BCA Design Assessment Report

The Robertson Hotel
1 Fountaindale Road
Robertson NSW 2577

Project: The Robertson Hotel
 Document Type: BCA Design Assessment Report
 Our Reference: P218_204-2 (BCA) LB

Figure C2.8a – Level 3/4

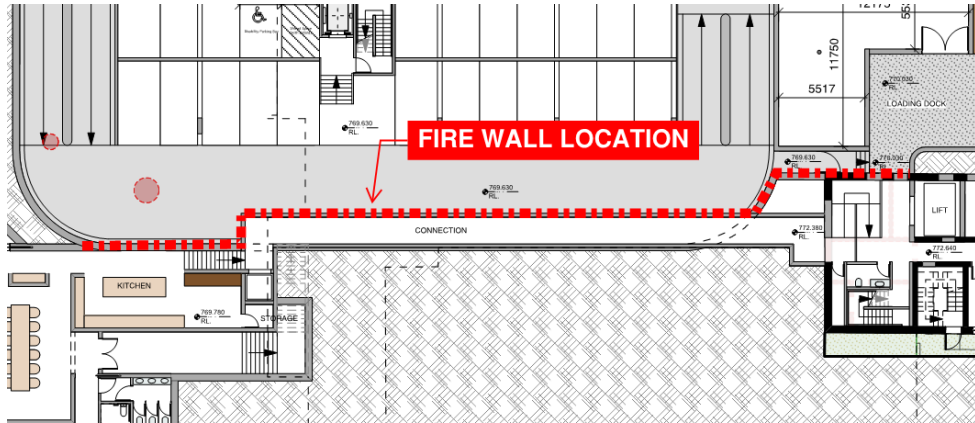
The following areas highlighted in the figures below are noted as having different classification located alongside one another in the same storey and hence the following options are provided –

- (i) **Option 1** – Introduce fire walls complying with C2.7, separating the different classifications. Location of fire wall locations are highlighted in the figures below; or

- (ii) **Option 2** – In lieu of the provision of fire walls, all relevant building elements in the storeys having different classifications are to be constructed to achieve the higher FRL prescribed in Spec. C1.1. This includes the intervening floor separating the parts above.

Figure C2.14 - Corridor length (Typical)

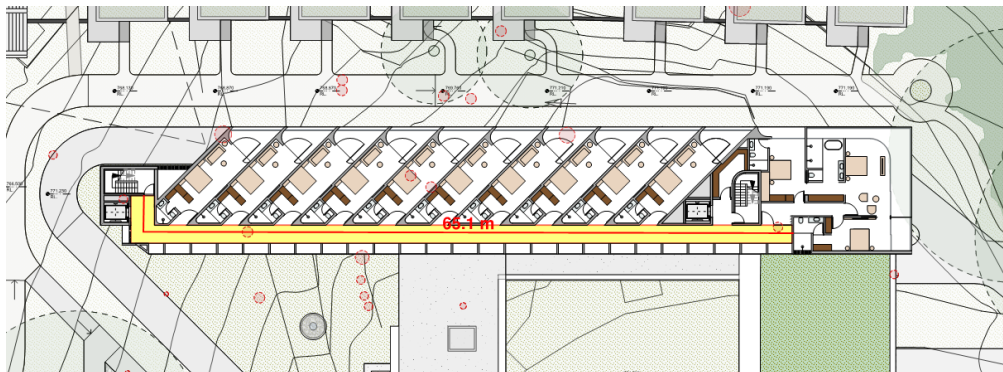
C2.14 The eastern extension to the existing main building is proposed to accommodate 3 levels of sole occupancy units, with the public corridors exceeding 40m in length without provision of smoke proof walls (being up to ~65m), as highlighted in figure 1 below.

To address the compliance departure identified above, the following options are offered for resolution –

Figure C3.3a – Eastern extension (level 4 to level 6 typical)

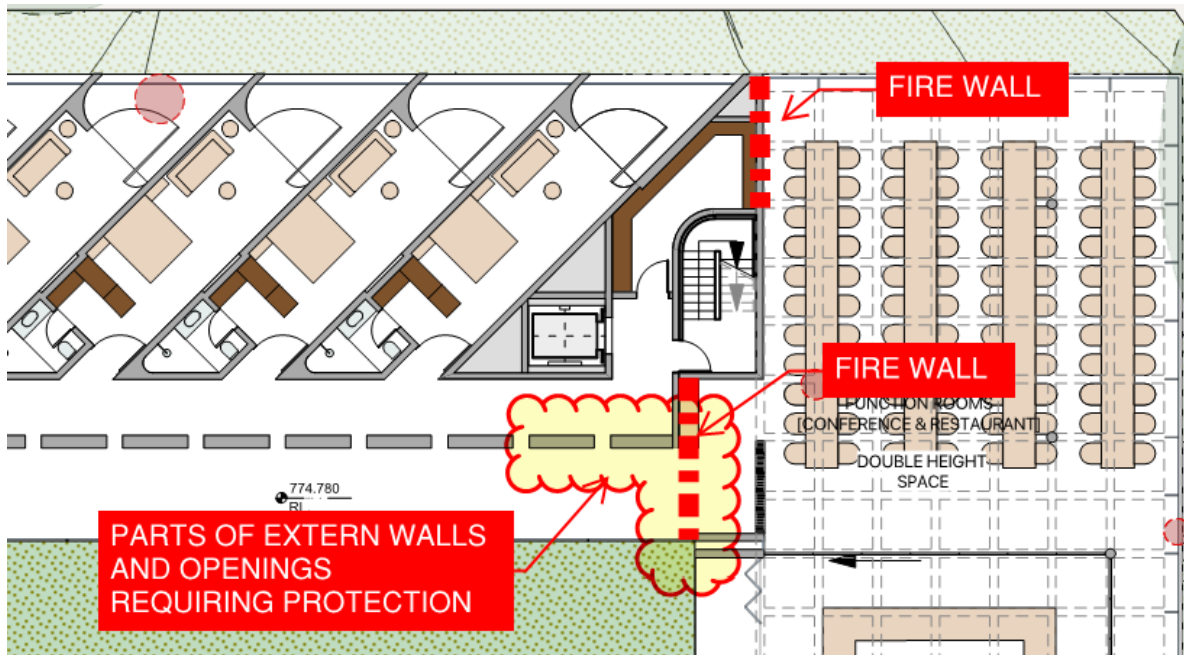
- (i) Each wall must have an FRL of not less than 60/60/60; and
- (ii) Any openings protected in accordance with C3.4.

The location of the subject areas requiring protection are highlighted in the figures below.

Figure D1.4a – Travel distance in pool area

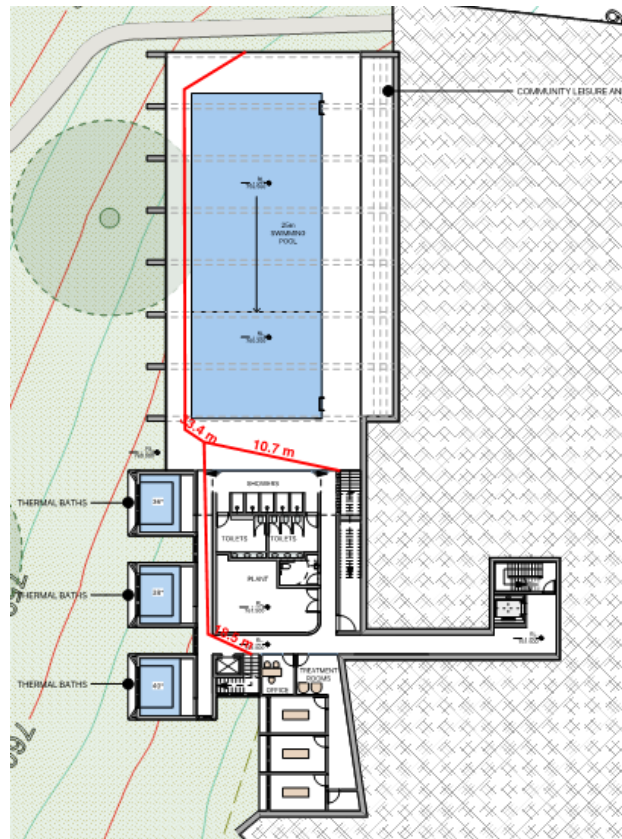
Travel distances within the development have been assessed as generally being compliant with the exception of the following areas, as detailed below in figures below -

- (i) The travel distance to a point of choice to alternative exits within the swimming pool area exceeds 20m, being up to ~34m. Additionally, the overall travel distance to the nearest exit exceeds 40m, being up to ~44m; and

To address the extended exit travel distances identified, the following options are offered for resolution –

Figure D1.4b - Travel distance within community health and leisure centre

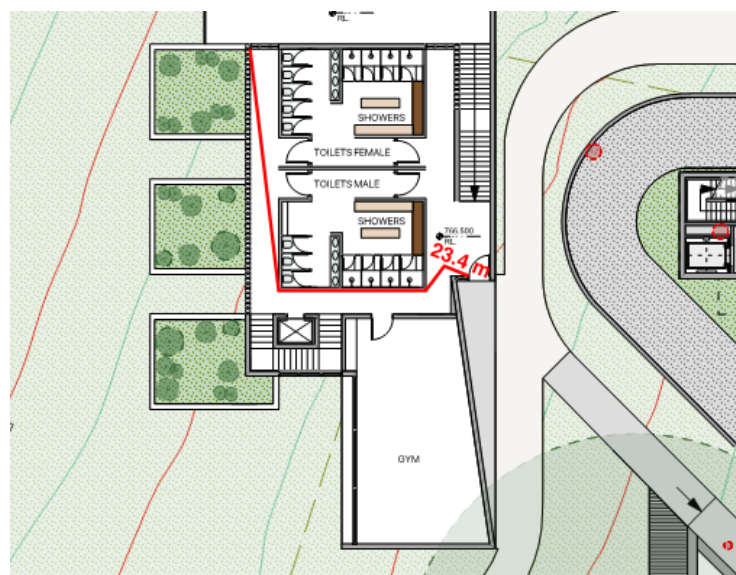
- (ii) The travel distance to the single exit from the upper level of the community leisure centre exceeds 20m, being up to 24m;

Figure D1.4c – Travel distance within level 3 carpark

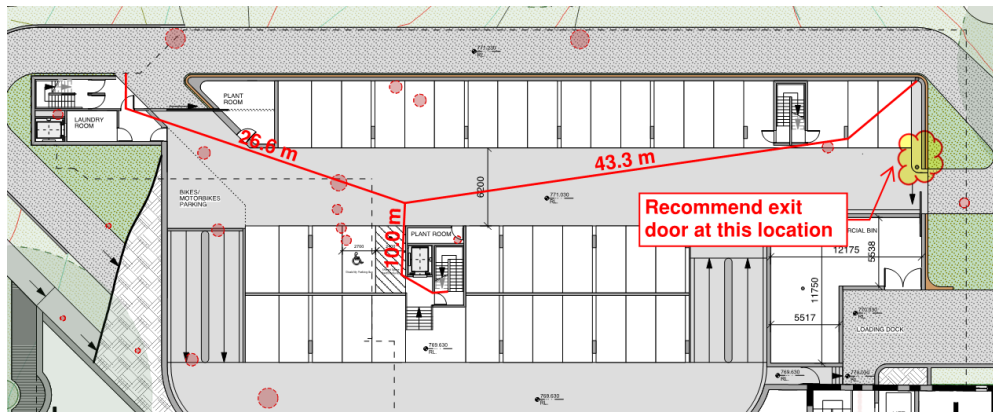
- (iii) The travel distance to a point of choice to alternative exits from the southern part of the level 3 carpark exceeds 20m, being up to 44m. Additionally, the overall distance to the nearest exit exceeds 40m, being up to 54m.

Figure D1.5 – Extended travel distance between exit in class 3 part

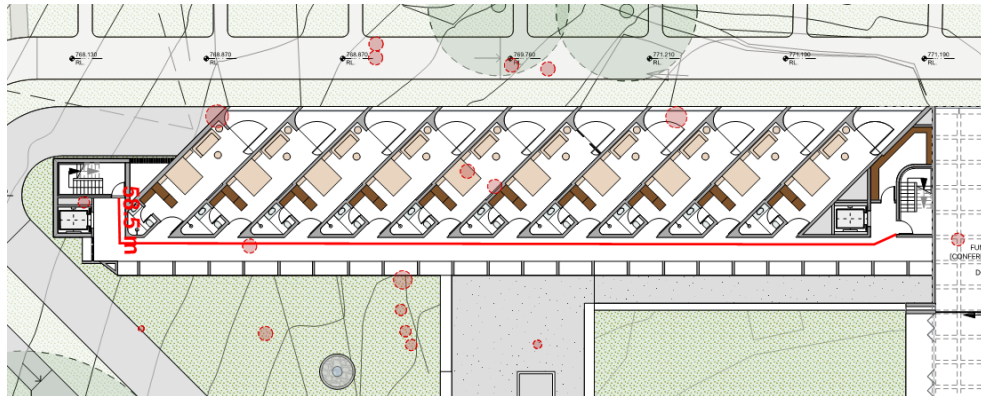
The distance between alternative exits within the class 3 public corridor of the eastern extension of the main building exceeds 45m, being up to ~59m.

To address the extended exit travel distances identified, the following options are offered for resolution –

Figure D1.7 – Location of fire isolated stairways in main building

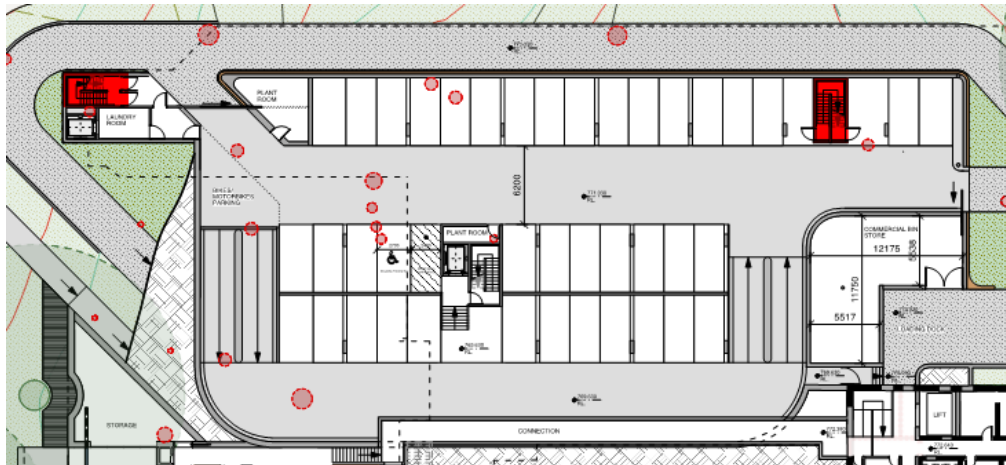
The fire isolated stairway within the main building are highlighted **red** in the figure below, with the following items noted.

- (i) The northern fire isolated stairway is noted as discharging to a covered area and the path of travel from the point of discharge requires occupants to pass by within 6m of the external wall and openings within the external wall of the building before reaching the open space;
- (ii) The southern fire isolated stairway discharges internally within the building in lieu of directly external to the building or to a covered area, or within the confines of the building, as permitted by D1.7 of the BCA.

To address the above, ensure that the fire isolated stairways, discharge directly to –

- (a) a road or open space; or
- (b) a point—
 - in a storey or space, within the confines of the building, that is used only for pedestrian movement, car parking or the like and is open for at least 2/3 of its perimeter; and
 - from which an unimpeded path of travel, not further than 20 m, is available to a road or open space; or
- (c) into a covered area that—
 - adjoins a road or open space; and
 - is open for at least 1/3 of its perimeter; and
 - has an unobstructed clear height throughout, including the perimeter openings, of not less than 3 m; and
 - provides an unimpeded path of travel from the point of discharge to the road or open space of not more than 6 m; or

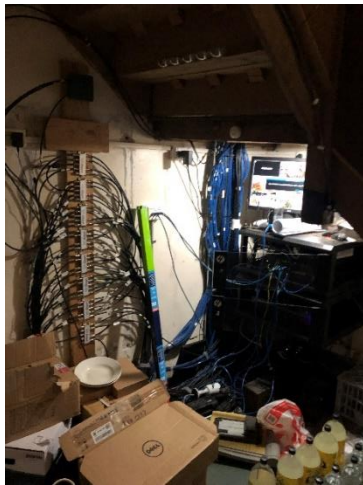
D2.2	Concern is raised with the materials used to construct the required fire isolated stairways, being not in accordance with D2.2 of the BCA.	Accept existing on the basis the building will be sprinkler protected throughout.
D2.3	Concern is raised with the materials used to construct the required non-fire isolated stairways, being not in accordance with D2.3 of the BCA.	Accept existing on the basis the building will be sprinkler protected throughout.

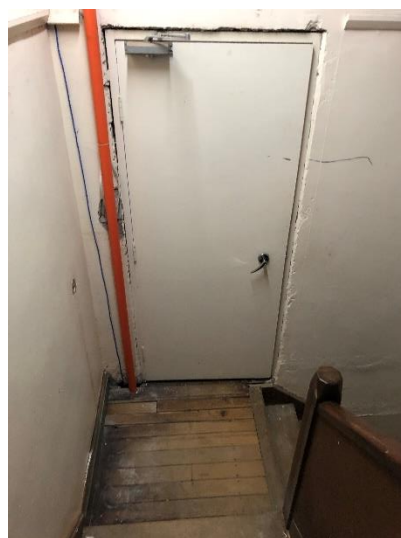
| D2.20 | The door opening to the western fire isolated exit on the first floor, encroaches into the required width of the exit stairway by more than 500mm. | Accept existing. |
